KINGSTON FOSSIL PLANT (KIF) - ANNUAL INSPECTION OF WASTE DISPOSAL
AREAS

KINGSTON FOSSIL PLANT- ANNUAL INSPECTION OF WASTE DISPOSAL AREAS

An annual inspection of the ash pond dikes and toe areas at KIF to ensure structural stability was conducted April 2, 1996. The inspection was conducted by Cherie Minghini of Fossil Engineering and Jim Huber of Fossil Fuels. The previous stability inspection was conducted on April 13, 1995.

PICTURE 1- GULLIES AND ERODED AREAS ALONG NORTH DIKE

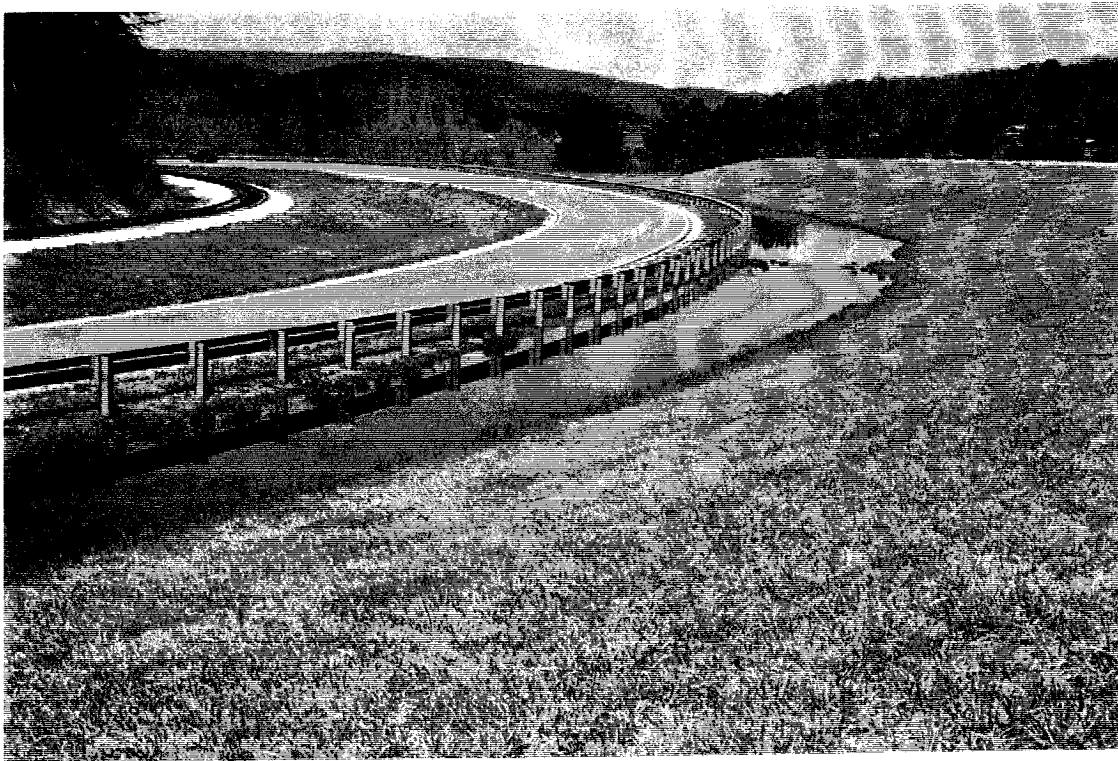
The dikes appear to be stable. There is a good crushed stone surface on the dike roads. A good vegetative cover is present on the dike slopes; however, there are a few bare areas on the slopes of the north dike. Any bare areas should be seeded and mulched to establish a good vegetative cover and prevent any additional erosion. Runoff water from the top of Dredge Cell No. 1 dike is forming gullies down to the eastern end of the north dike drainage ditch. Riprap has been placed in the eroded area, but additional riprap is necessary to prevent additional erosion. The drainage ditch along the north dike is still eroded, primarily on the eastern end. There is an area of ponded water on the western end of the north dike. The dike adjacent to Swan Pond Road has a few areas of ponded water, primarily at the northernmost end of the dike. The 50' sluff identified in previous ash pond inspections located on the west end of Dike "C" about 150 feet from Swan Pond Road was still present, but does not appear to be worsening and does not appear to be a stability problem.

Plant personnel have placed some riprap in the erosion gullies of the north dike; however, more riprap should be placed in the gully.

Riprap should be placed in erosion gullies along the north dike. Earthfill should be placed and compacted along the north dike drainage ditch in eroded areas. These areas should be seeded and mulched to help prevent additional erosion.

PICTURE 3- SPILLWAY DISCHARGE OUTLETS

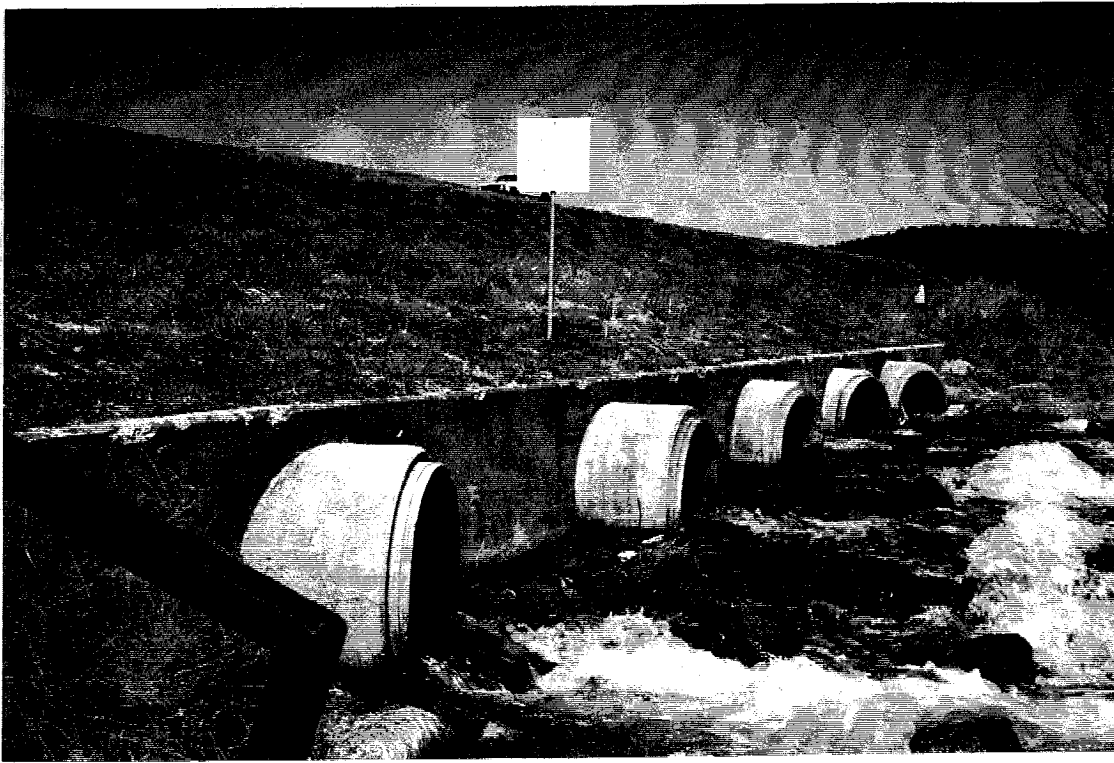
There has been no change in operation of the active ash pond since last inspection. Bottom ash continues to be sluiced into a channel at the southwest end of the pond. Bottom ash falls out and is removed by dragline. Fly ash is sluiced into a trench parallel and to the west of the bottom ash channel. The bottom ash and fly ash waters flow through the ash pond and through two field spillway/skimmers to the stilling pool. The plant constructed spillways/skimmers were discharging at the time of inspection and appear to be in good condition. Discharge to the intake channel is through five of six standard spillways and skimmers. At the time of the inspection, five outlet pipes were discharging with no visible loss of ash. The spillway on the west end has been raised and is not discharging. The riprap at the spillway outlets appeared to be in good condition with no signs of erosion.

PICTURE 4- EROSION IN SOUTHEAST CORNER OF STILLING POOL. NOTE THAT SOME RIPRAP HAS BEEN PLACED.

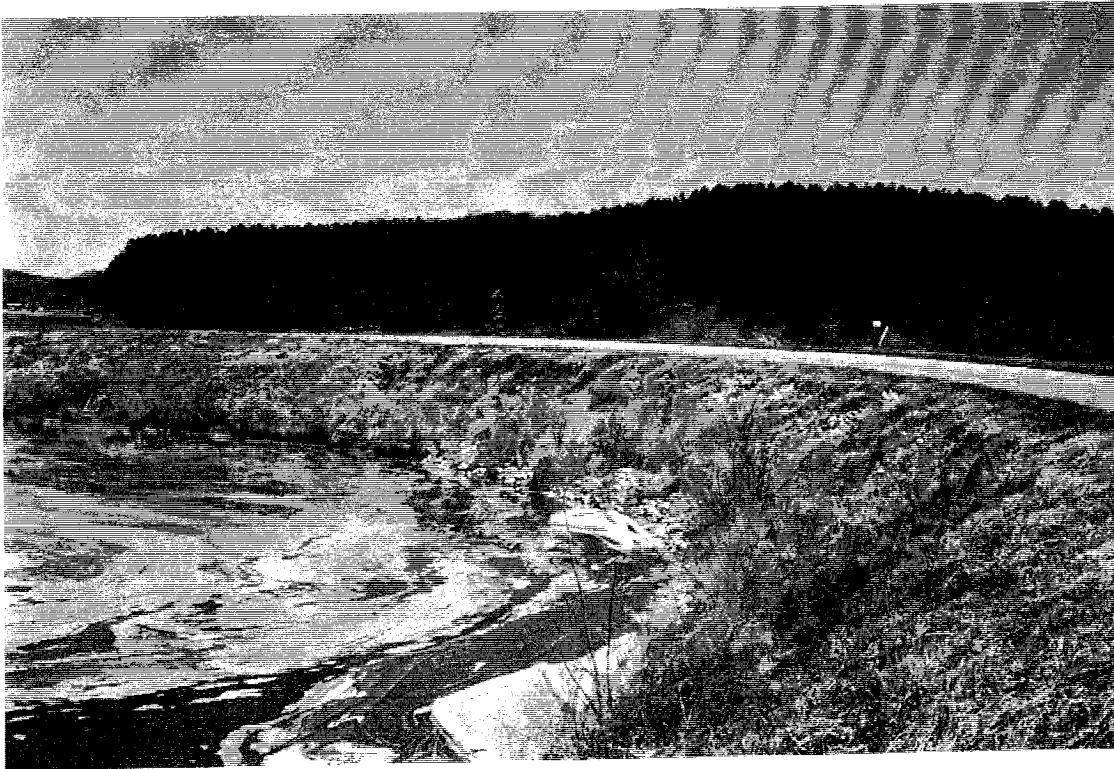
The dikes appear to be stable and did not exhibit any notable changes in the exterior dikes since the last inspection. A good vegetative cover was present on all exterior slopes. There is a good crushed stone surface on the dike roads. There are several areas of standing water along Dike "C" where the ditch is not draining. There is a 150' long area of rutting and standing water on the east side of the active ash pond. There is an erosion gully caused by discharge from a dike storm drain about 150 feet north of the stilling pool. The concrete around the monitoring wells 5B and 5C along Dike "C" is cracked up and in poor condition. The inside of Dike "C" has a few areas of minor erosion on the east side of the stilling dike caused by wave erosion. The ditch on the south dike is not draining in areas. This is partially due to one of the drains in the toe ditch that is clogged and not draining. There is a 25' long minor surface sluff on the south dike of the active ash pond. This sluff does not appear to be a threat to the stability of the dike. The divider dike at the stilling pool appears to be stable; however, there is some erosion due to wave action evident on the north side of the stilling pond. Some of this area has been filled and covered with earth; however, erosion still persists in this area. When earth is placed, the area should be seeded and mulched so that a good vegetative cover is established to prevent additional erosion. There is some minor accumulation of floating ash in the southeast corner of the stilling pool.

Riprap has been placed in areas where wave erosion has undercut the inside of the ash pond dike and stilling pond dike; however, plant personnel should continue to monitor for wave erosion and add riprap if necessary.

Riprap should be placed in areas where wave erosion has undercut the inside of the stilling pool dike.

PICTURE 6- FLY ASH DISCHARGE TRENCH- RIPRAP SHALL CONTINUE TO BE
REPLACED WHEN NECESSARY

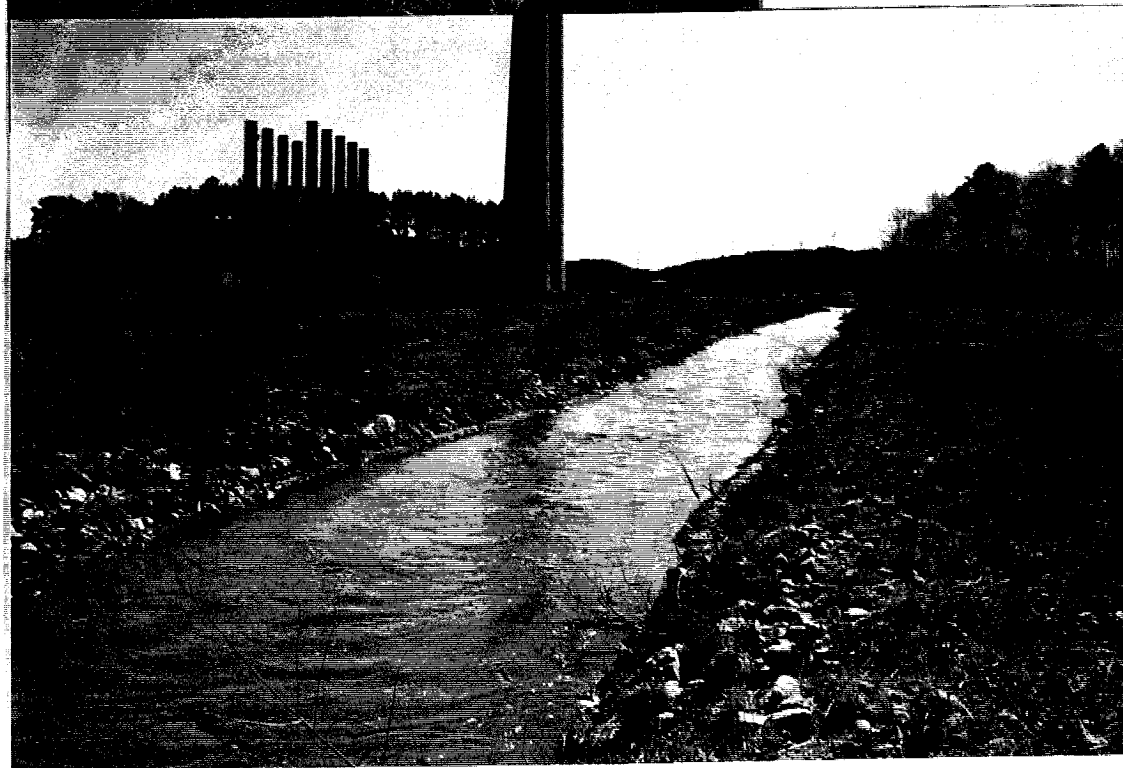
The fly ash continues to be sluiced into a rubber-lined ditch. The lining has deteriorated. Plant personnel have cleaned out the ditch and placed earth fill and riprap on the slopes for approximately 150 feet of the ash sluice ditch.

Plant personnel have not replaced the rubber liner; only the first 150' of the fly ash discharge ditch has been replaced with rip rap.

Plant personnel should replace the rubber liner in the fly ash sluice ditch or continue to clean out the ditch and fill with earth liner and riprap as required.
